BAR Meeting
July 20, 2011

ISSUE: Permit to Demolish/Encapsulate and Alterations

LOCATION: 329 North Saint Asaph Street

BAR CASE #2011-0182 & 0183

Figure 5: Existing and proposed site plan.

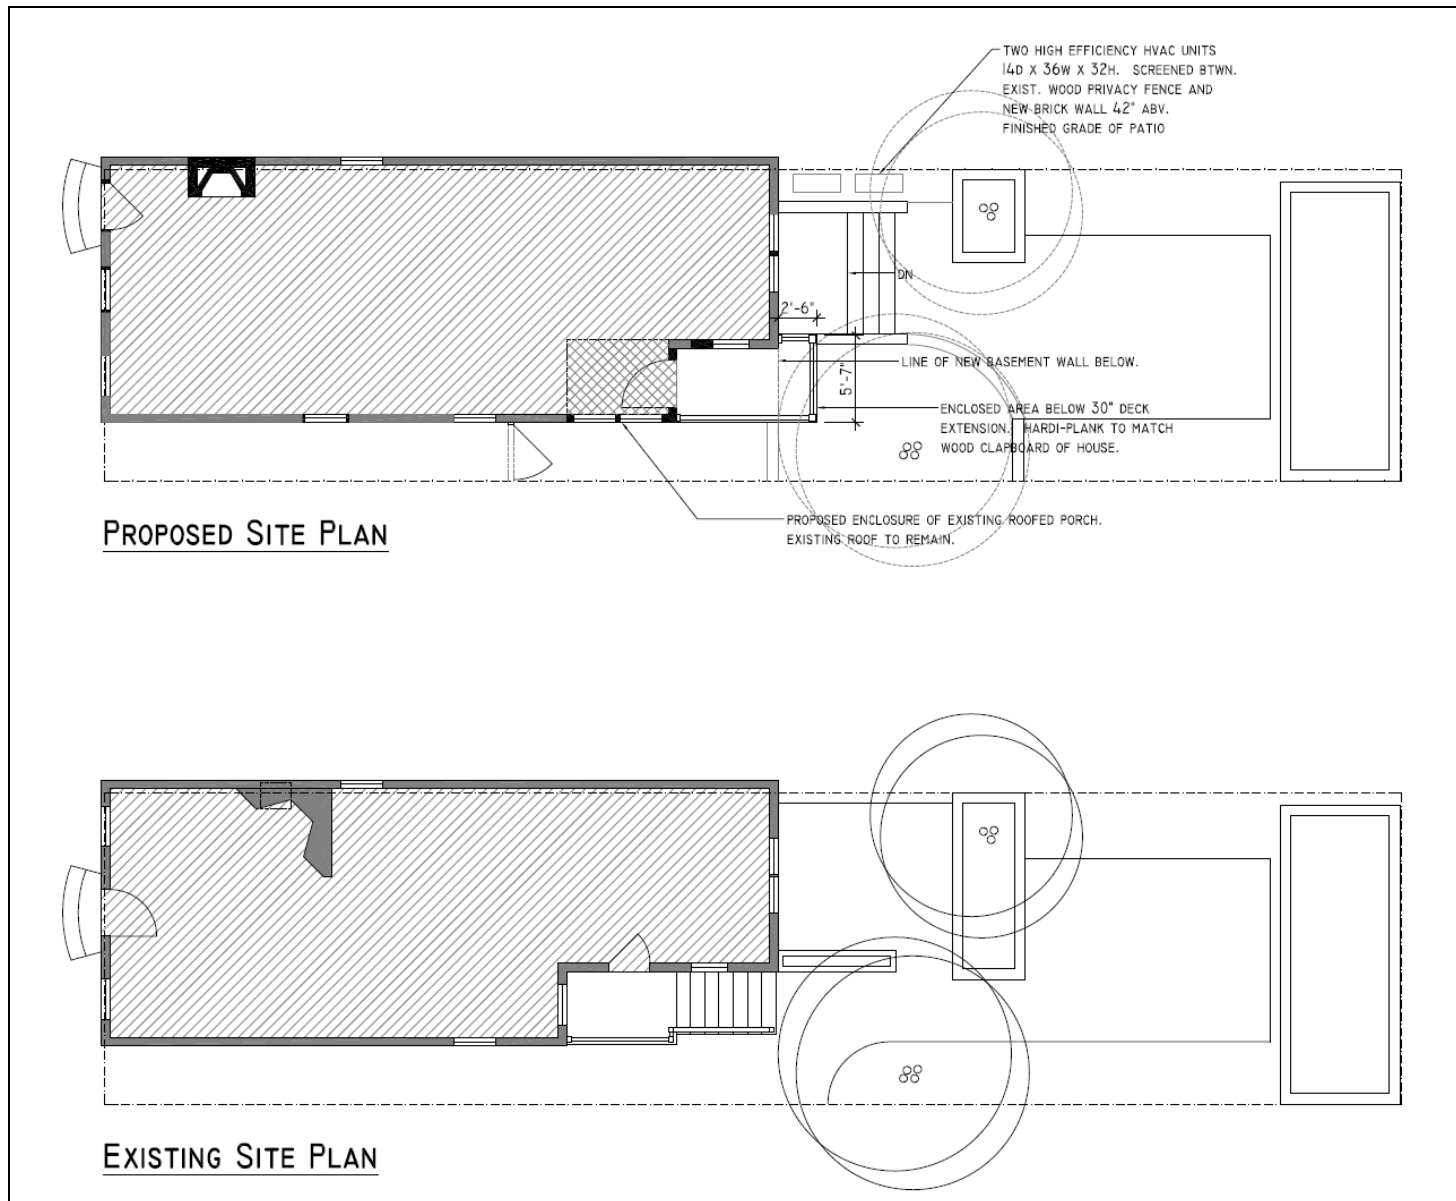
The adjacent property owner at 327 North Saint Asaph Street, had expressed concerns to Staff and the owner about the size and design of the proposed rear deck, as well as the location of the AC condenser units. Although the HVAC units and new basement entrance are not visible from a public way and are not subject to BAR review, the applicant reduced the size of the rear deck by half, relocated the AC condenser units to the north property line and screened the AC condenser units with a low brick wall. The adjacent owner also originally expressed concern about the impact of construction and basement excavation. However, these constructability issues are not before the BAR and are addressed by Code Administration and T&ES as part of the building permit and inspection process.

C-2 Applicant must submit proposed open space calculations and show improvements on a survey plat to determine if proposed rear deck and basement egress steps comply with the required open space.

C-3 Applicant should screen HVAC units under the deck facing neighbor.

Figure 6: Existing first floor plan.

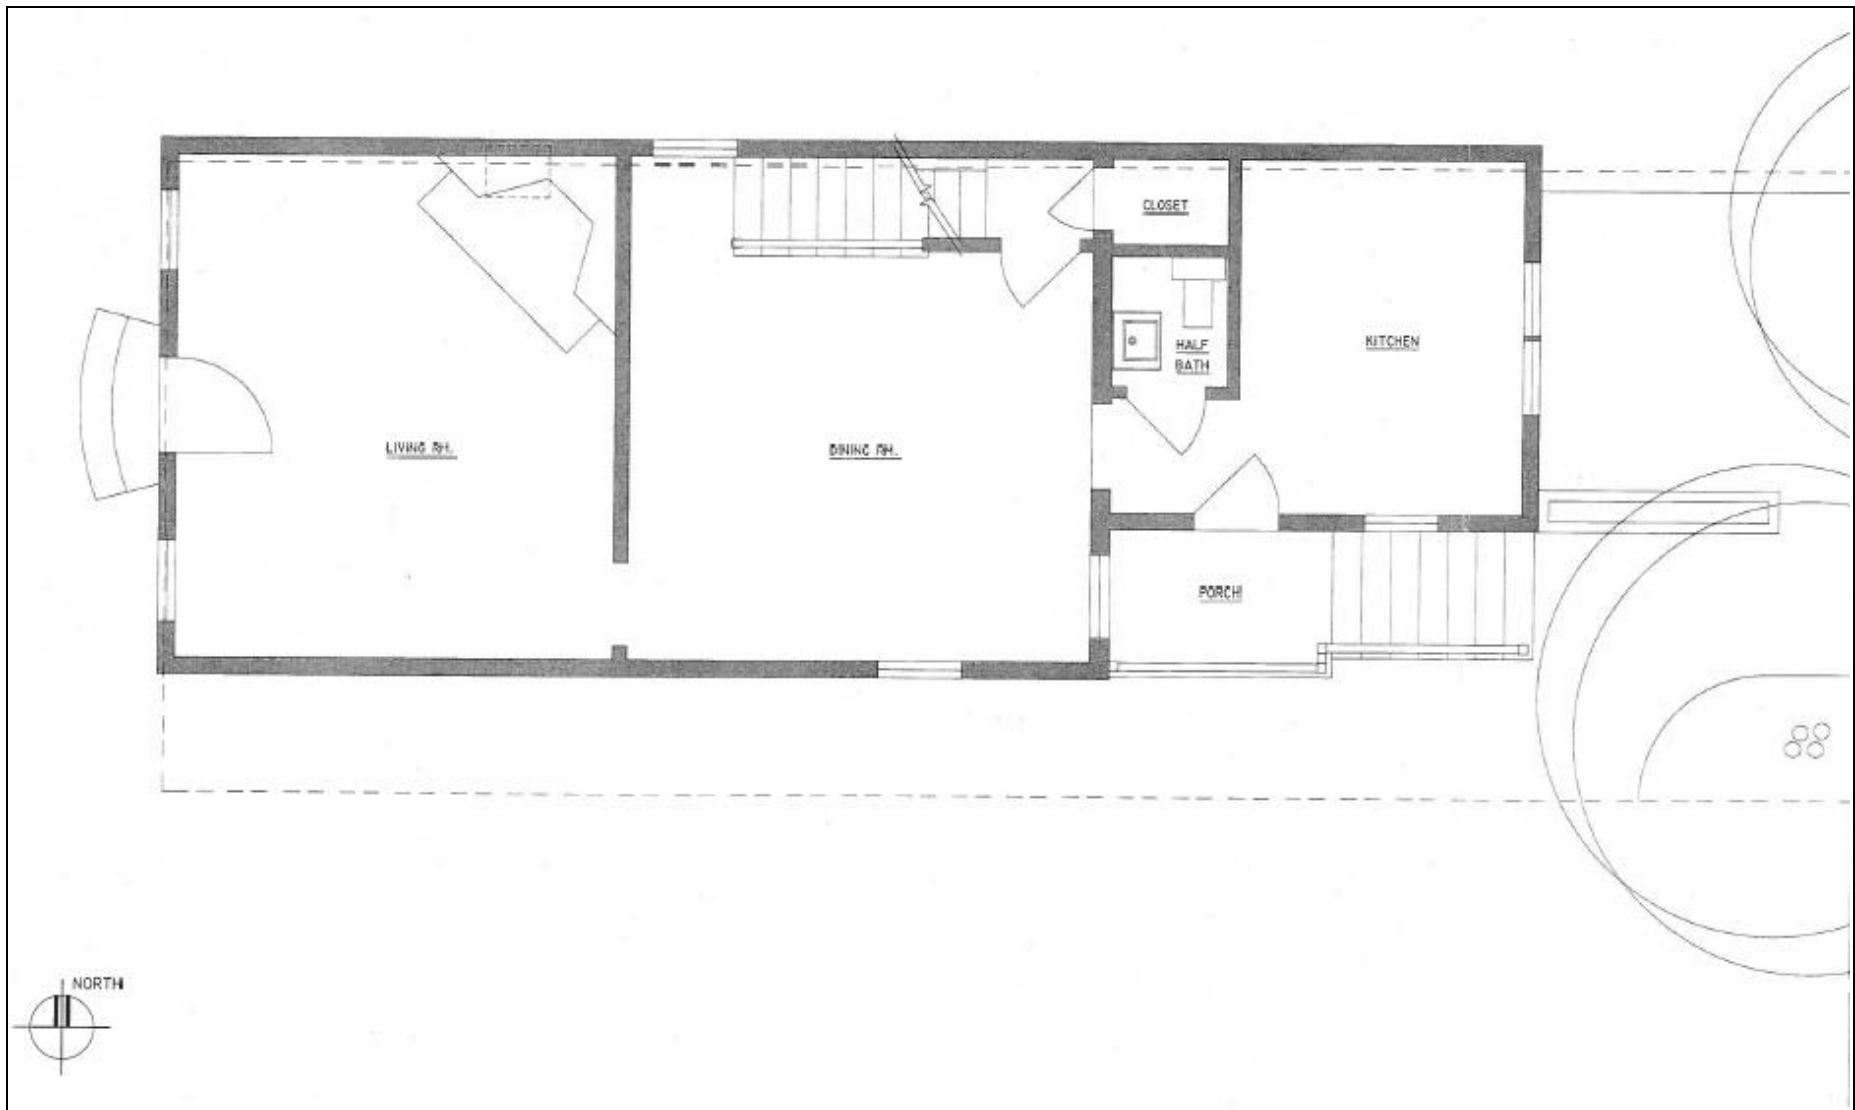
Converting an open side or rear porch to an enclosed porch is common in the historic district. This type of alteration allows the porch element to continue to read as a porch while providing for expanded interior space without expanding the footprint of the structure. In addition, it is an easily reversible alteration. Staff finds that this alteration will be minimally visible from North Saint Asaph Street and is not visible from Princess Street. The proposed materials are appropriate for an enclosed porch and are compatible with the existing building. The Board has regularly approved fiber cement siding and high-quality and solid-through-the-core composite trim on new construction and additions and Staff believes its use here would help subtly differentiate between the historic body of the house and the newly enclosed porch.

Figure 8: Proposed front door.

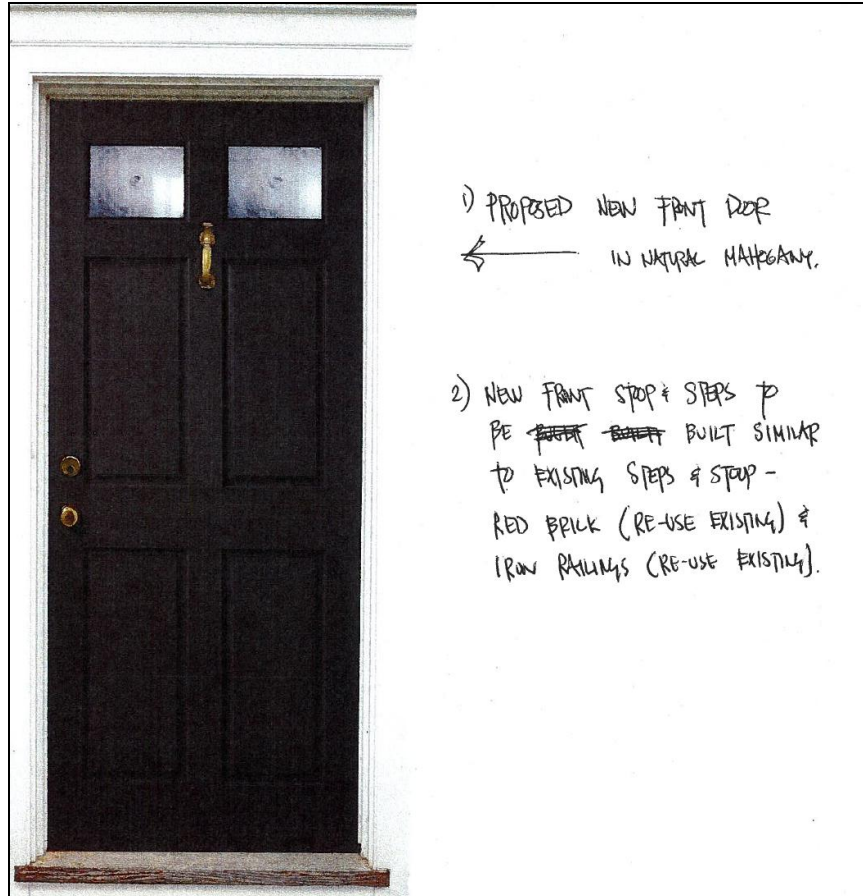
Staff supports the return of the front door to its original location. In a narrow urban townhouse, a center door entry would have been highly unusual because of such a location's adverse effect on the interior furniture layout. Staff recognizes that the 1965 relocation of the door to the center was part of a larger effort to "Colonialize" this building and, perhaps, recall more grand, center-hall Georgian period structures. These center hall buildings were typically five bay, freestanding buildings such as the original Gadsby's Tavern, which is not the case here. Staff has no objection to the return of the door to its original location and notes that this change will not detract from the Colonial Revival architectural style of the building. The side entry is more appropriate for this urban townhouse form, regardless of the architectural period or style, and is what is found everywhere else on this street. Staff also supports the proposed door, lantern and reuse of the railing and stoop design.
